Proposal for Supplement 2 to the 05 series of amendments to Regulation 48

Note: The text reproduced below was prepared by the expert from Poland. It supersedes ECE/TRANS/WP.29/GRE/2012/21 and was prepared in order to remove the present problem of the artificial 2,000 lm borderline and LED automatic levelling requirements. The modifications to the existing text of the Regulation are marked in bold for new or strikethrough for deleted characters, the modifications to ECE/TRANS/WP.29/GRE/2012/21 are marked in red.

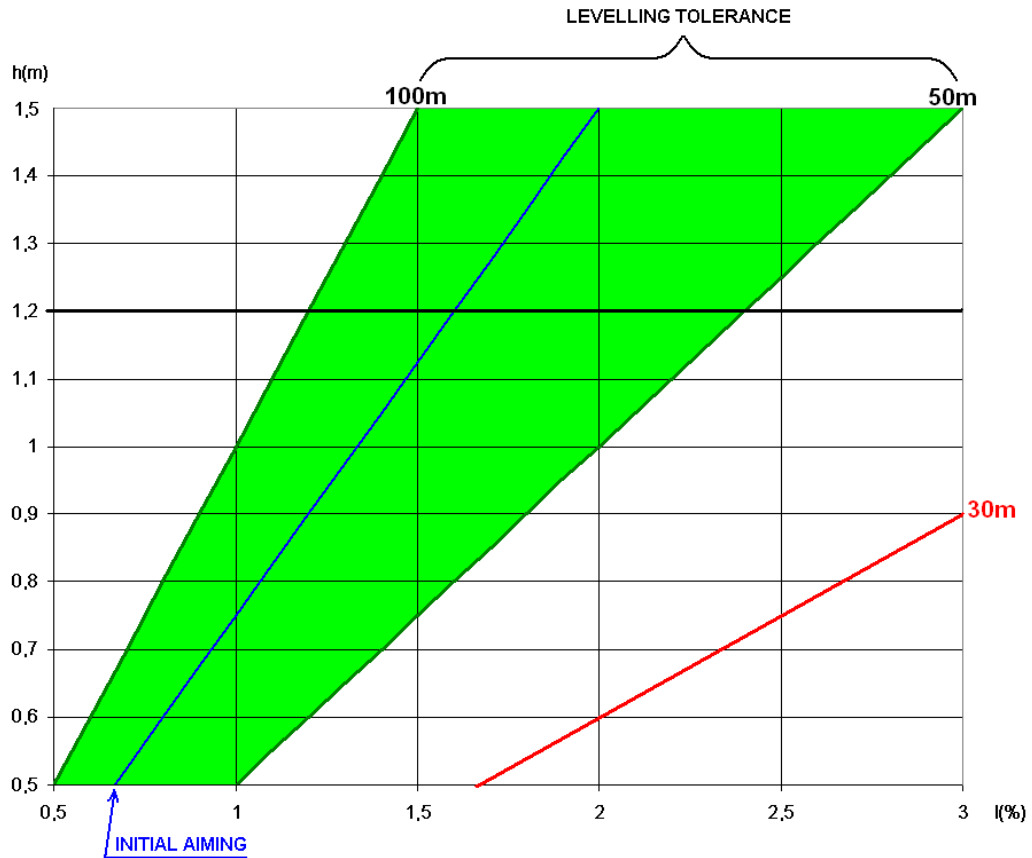
$h < 0.8$

limits: ~~between 0.5 per cent and 2.5 per cent~~

initial aiming: ~~between 1.0 per cent and 1.5 per cent~~

$0.8 < h < 1.0$

limits: ~~between -0.5 per cent and -2.5 per cent~~
initial aiming: ~~between -1.0 per cent and -1.5 per cent~~

$h > 1.0$

limits: ~~between -1.0 per cent and -3.0 per cent~~
initial aiming: ~~between -1.5 per cent and -2.0 per cent~~

The above limits and the initial aiming values are summarized in the diagram below.

"6.2.6.1.2. Depending on the mounting height in metres (h) of the **dipped-beam headlamp reference axis, the vertical inclination of the cut-off of the dipped beam, (in the direction of the reference axis) measured on the unladen vehicles, taking in account 0.1 per cent accuracy, shall have the value of initial aiming for which the horizontal part of cut-off crosses the surface of flat horizontal road at the distance of 75 m from the headlamp.**

The aiming limits under all the static conditions of Annex 5 should be such that the distance of crossing of the vertical part of cut-off with road surface shall remain between [50 m] and [100 m] including aiming inaccuracy.
